ADDENDUM 4

Date Issued January 30, 2026

Project Name | Job # White Earth Withdrawal Management Facility 20237410

THIS ADDENDUM AMENDS AND BECOMES PART OF THE CONTRACT DOCUMENTS FOR EAPC PROJECT 20245580 DATED 12/5/2025, RESPECTIVELY. EACH BIDDER SHALL ACKNOWLEDGE RECEIPT OF THIS ADDENDUM BY MARKING THE ADDENDUM NUMBER AND DATE ON THE BID FORM.

P101

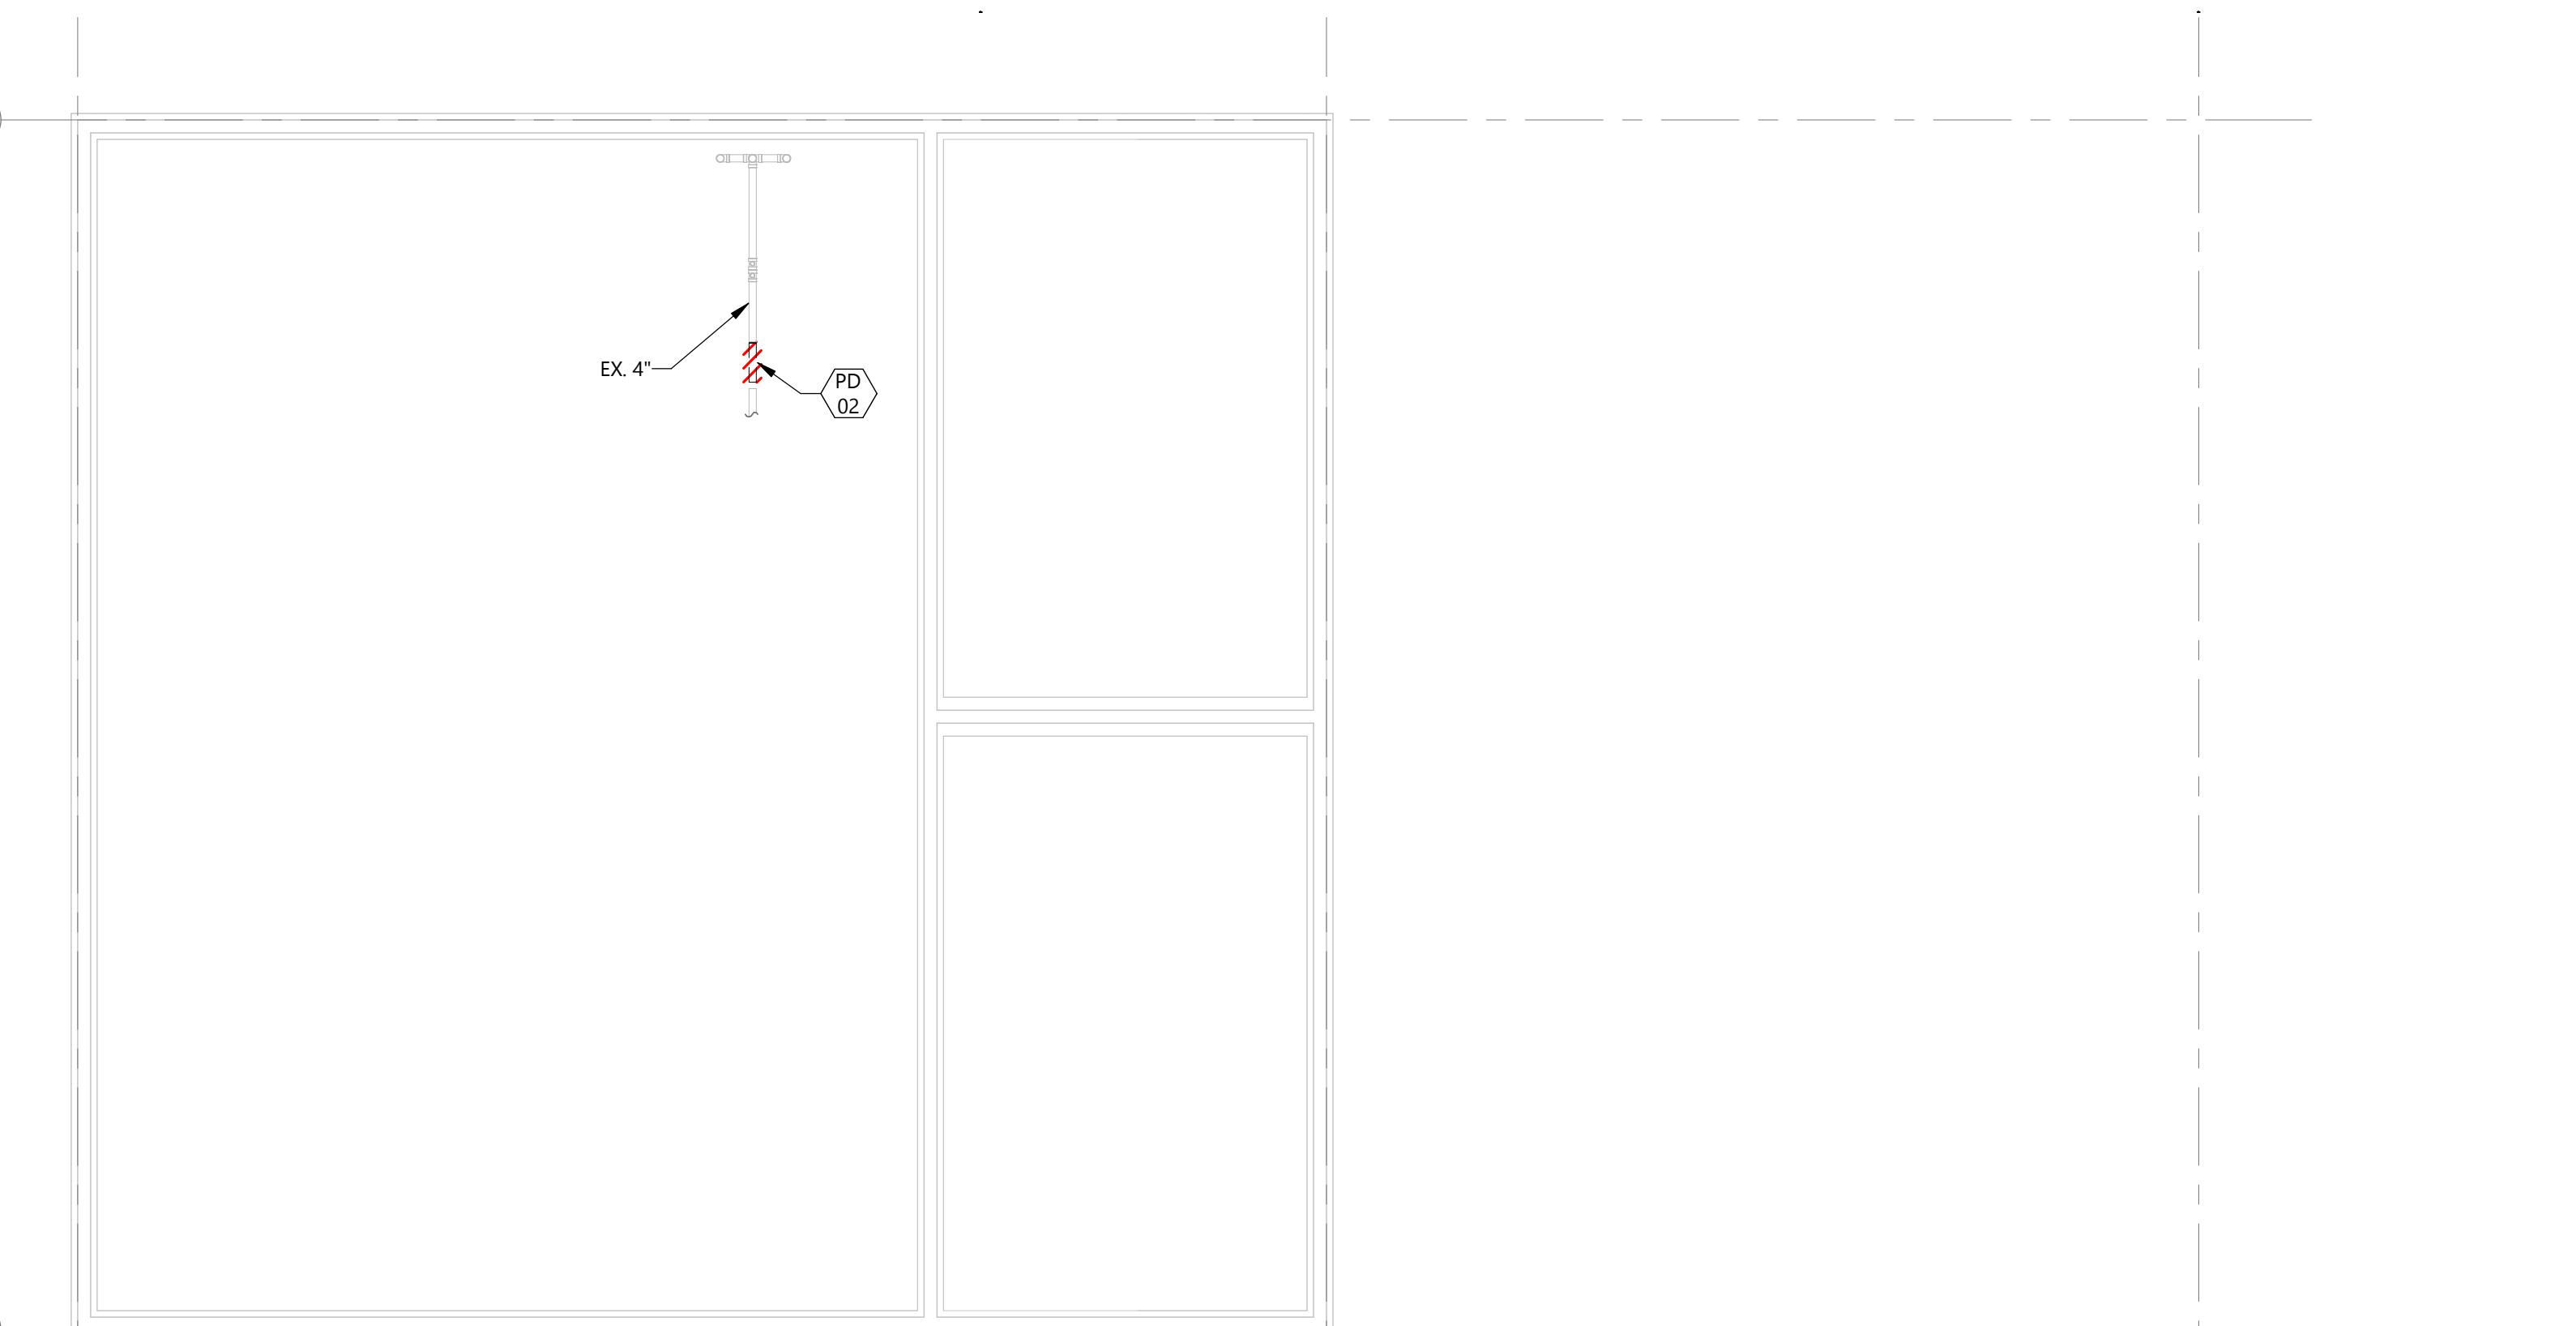
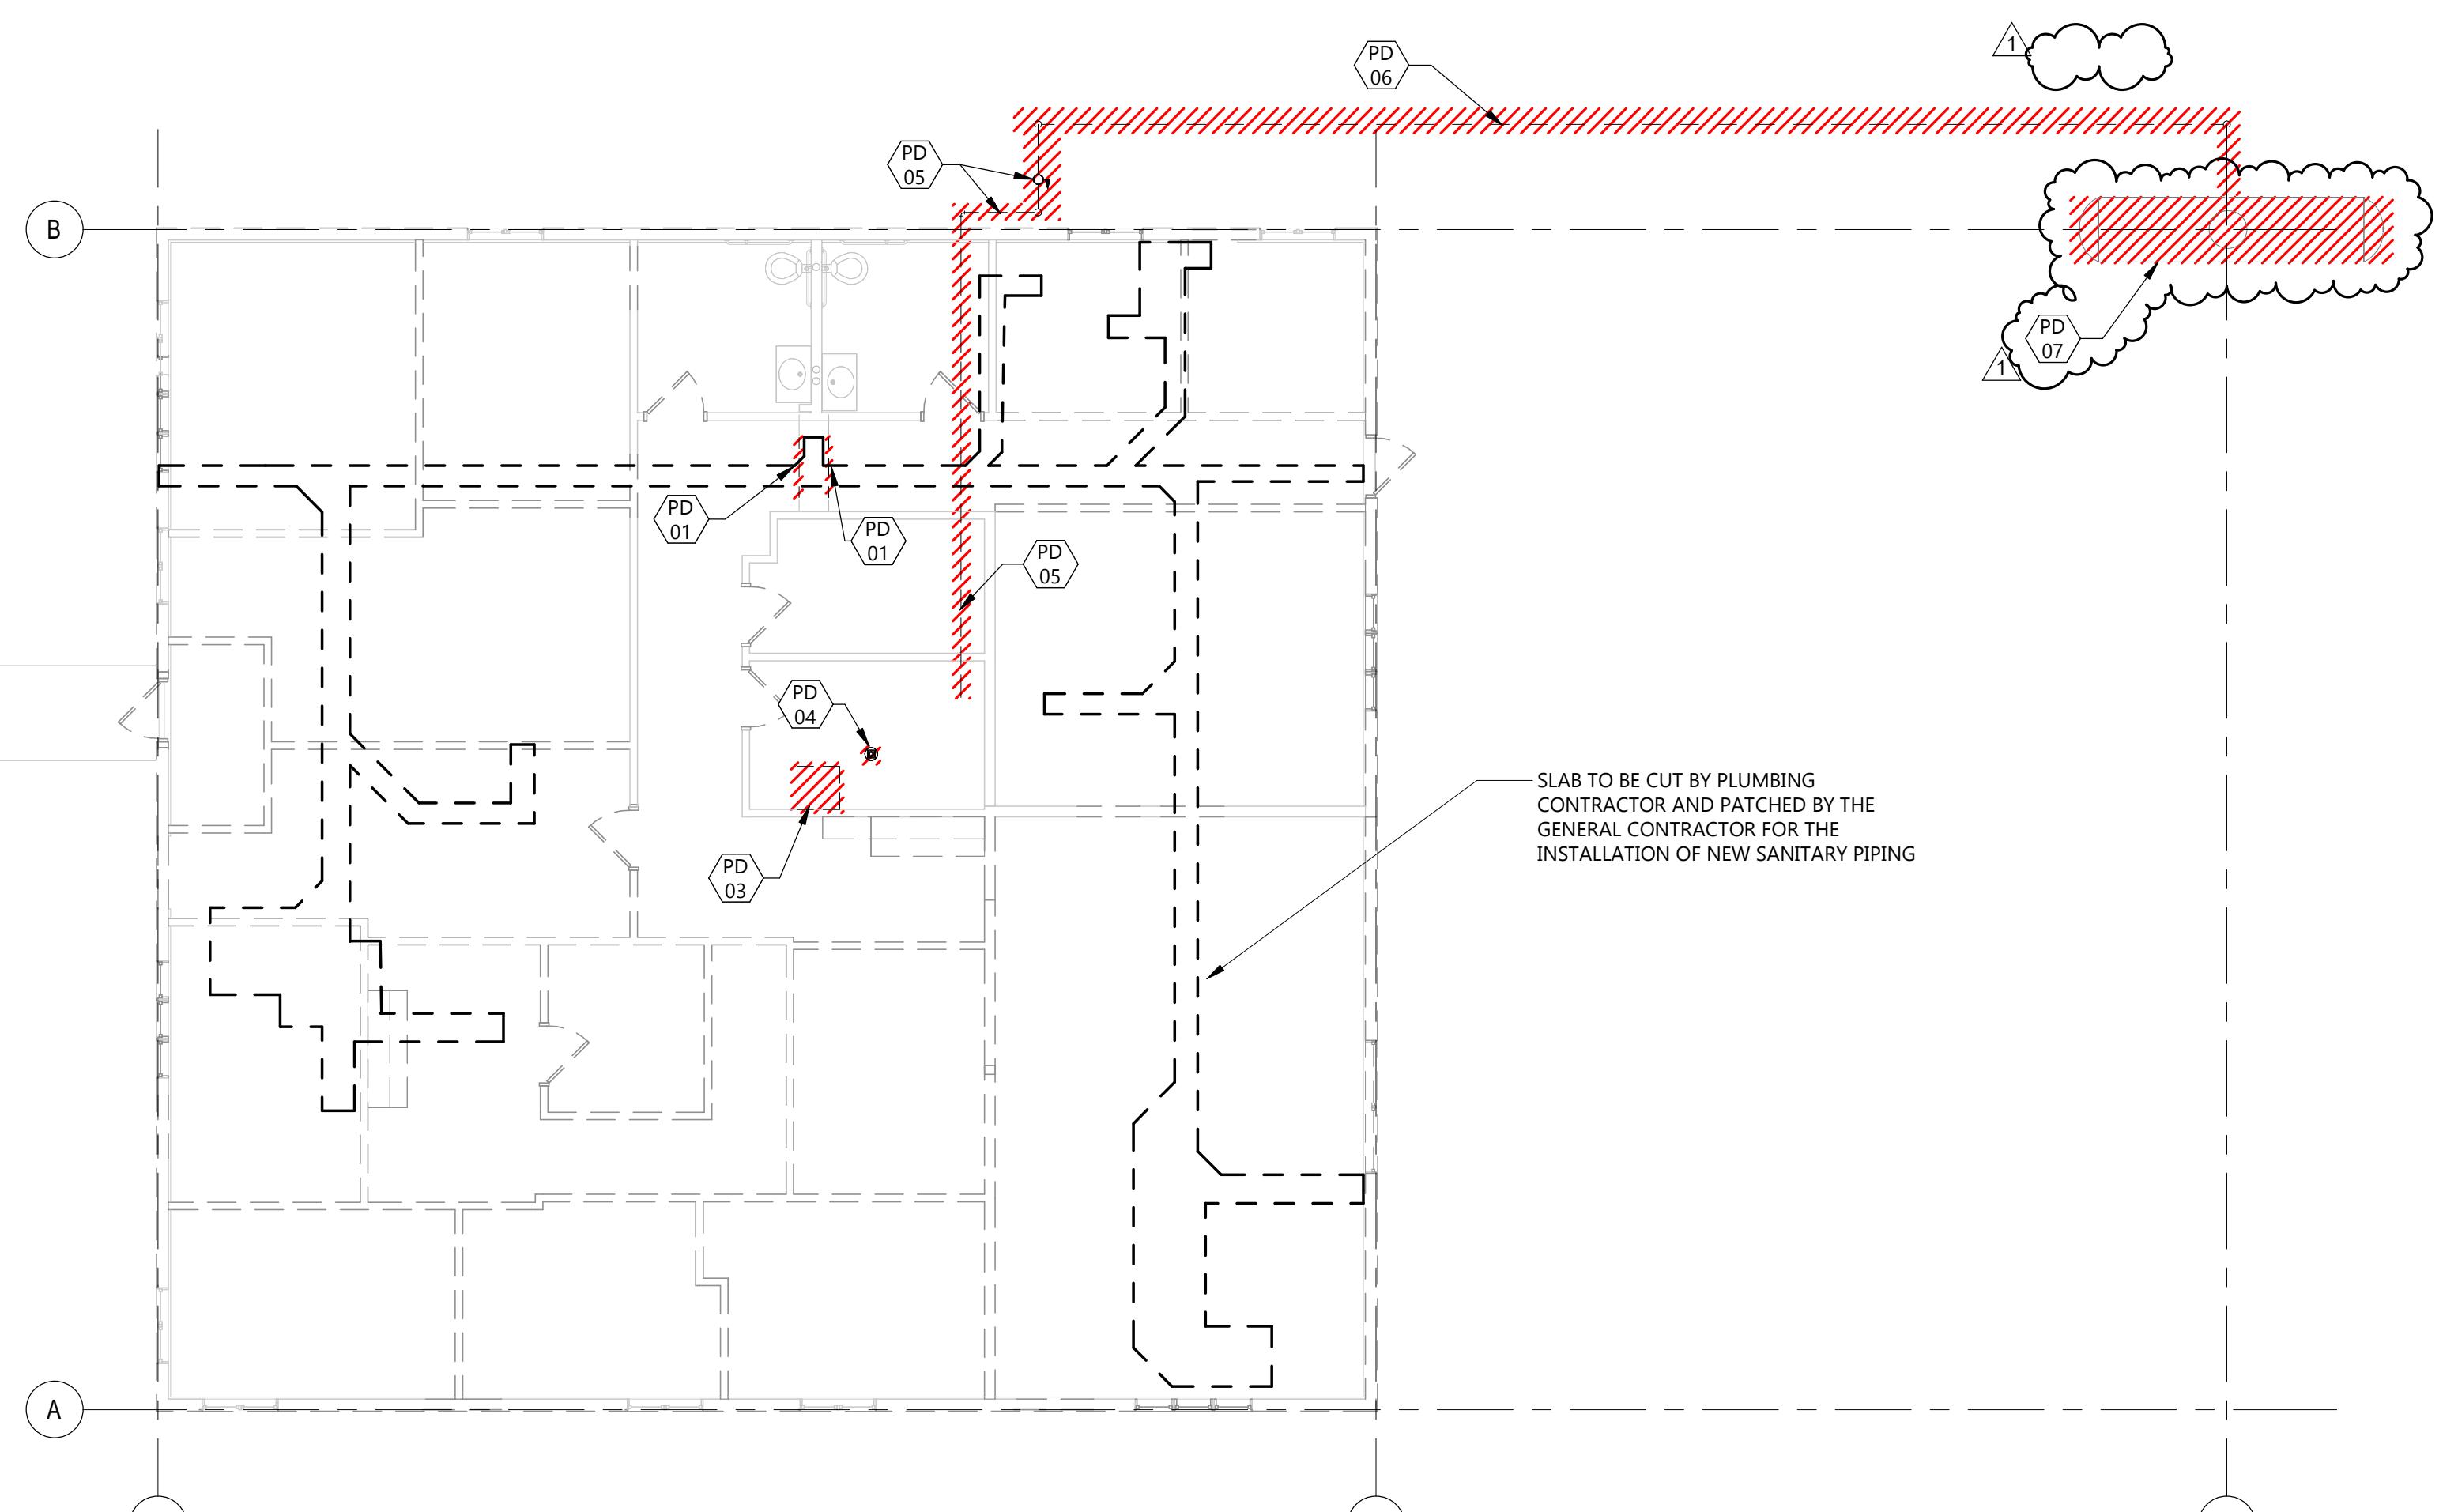
PD 07	DISCONNECT, REMOVE & TURN OVER TO OWNER OR DISPOSE OF AT OWNERS REQUEST EXISTING PROPANE TANK AS INDICATED BY HATCH. FIELD VERIFY EXACT SIZE & LOCATION AS REQUIRED.
